## **AIRWORTHINESS DIRECTIVE**

Ref. No. 2019-FATA-01020A-06

Applicability -- RRJ-95 aircraft

Fig.1

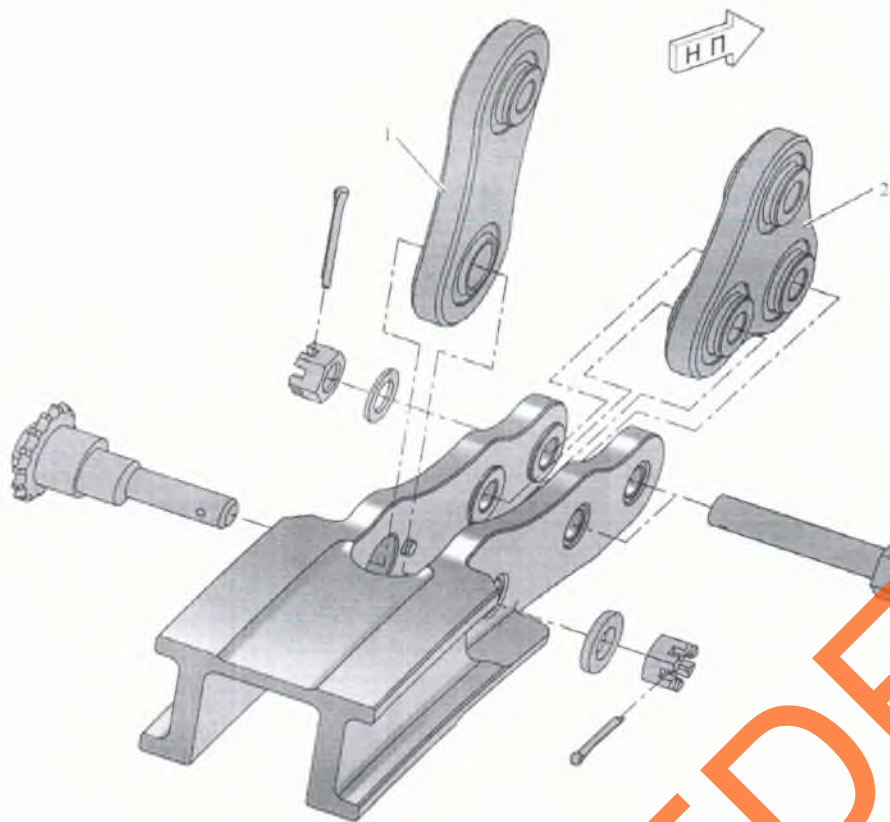
1. During the weekly WY-Check/8 DY on RRJ-95 A/C MSN 95030, 95037 and 95116-95220 to perform inspections of links of tracks (See Fig.1 (items1,2) and Fig.2 (item 3) and bearings of links of tracks of sections 2, 3 and 4 of a slat of LH and RH outer wing in accordance with provisions of p. 4. B. (2) and (6) of AMM Tasks Nos. 57-43-00-220-802, 57-44-00-220-802 and 57-45-00-220-802 until the implementation of SB No. RRJ-57-00451-BD “Wing – Replacement of link of track of a slat section”.

Fig.3

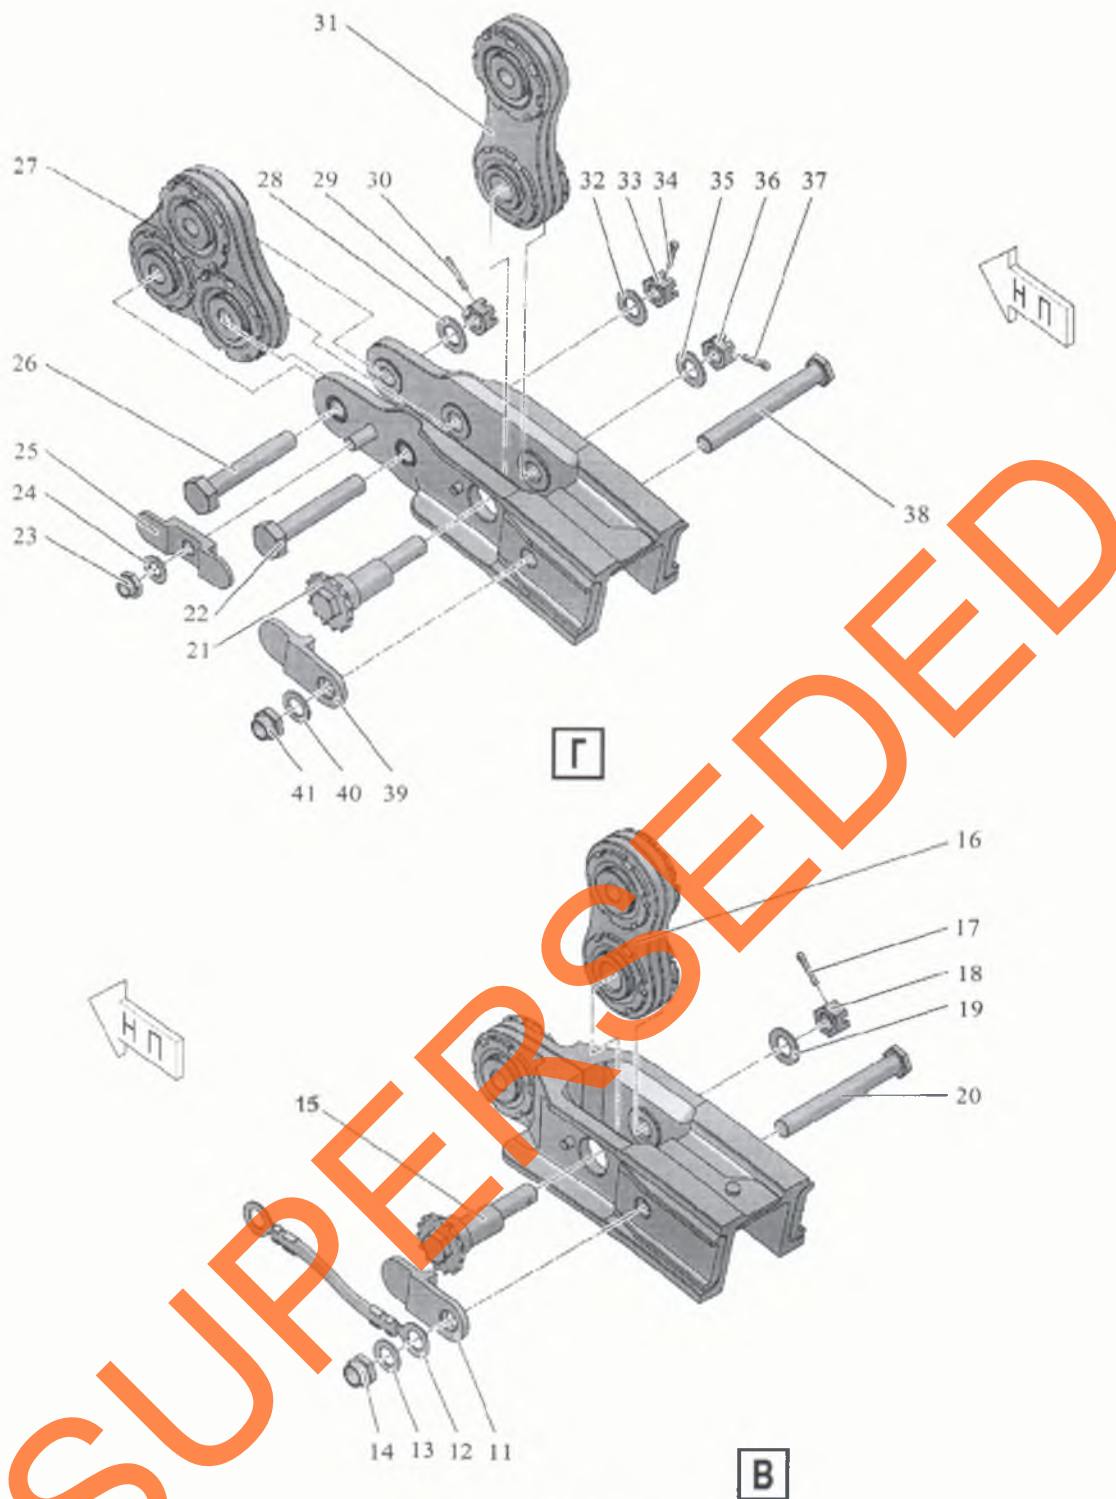
2. During the weekly WY-Check/8 DY on RRJ-95 A/C MSN 95007-95220 to perform one-time inspection of links of tracks (See Fig.3 (items16, 27 and 31) and bearings of links of tracks of section 1 of a slat of LH and RH outer wing in accordance with provisions of p. 4. B. (2) and (6) of AMM Tasks Nos. 57-42-00-220-802.

- For slat section 1 – to replace with the current configuration of link of track of section 1 of a slat, IAW AMM Task No. 57-42-00-900-804.
